ISSUE DATE: 11/13/2006  P 525633
APPROVAL DATE: 2/6/07  A 513574

**ON-SITE SEWAGE DISPOSAL SYSTEM
HOWARD COUNTY HEALTH DEPARTMENT
BUREAU OF ENVIRONMENTAL HEALTH**

SUBDIVISION: Pindell Woods LOT NUMBER: 40

ADDRESS: 11616 Mirror Pond court PROPERTY OWNER: Dale Thompson Bldrs

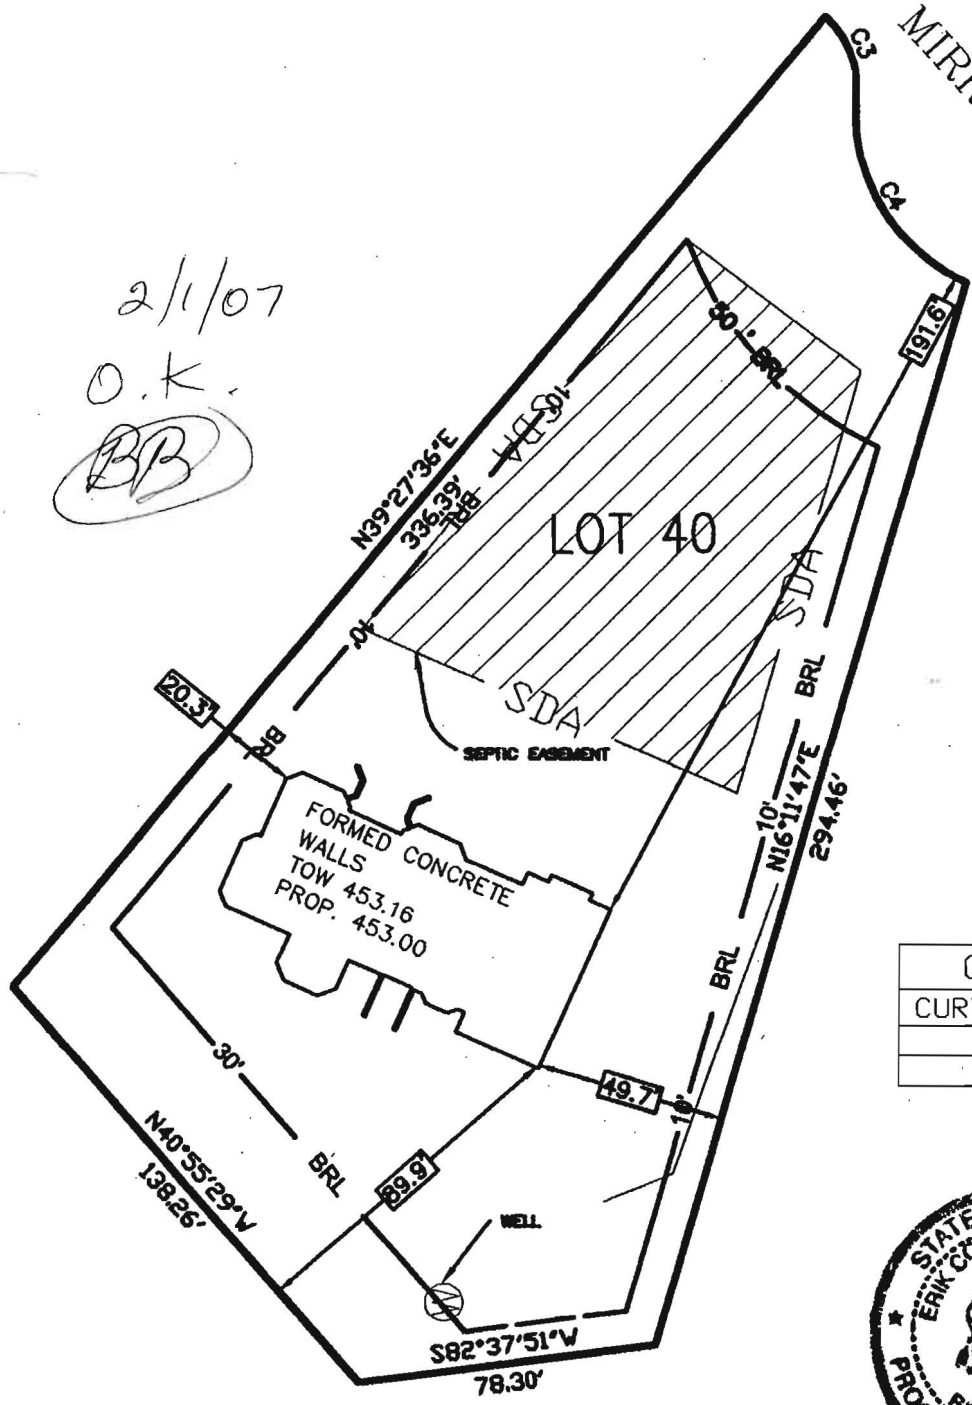
PRE-CONSTRUCTION 2/1/07 Easement not staked. Fill on upper part of easement. Should be able to install two 100' installation trenches across the top of the easement. Will have to check contour after fill is removed. Change inlet depth to 4' and trench bottom depth to 7'. (BB)

2/6/07 System finished. O.K. to cover (BB)
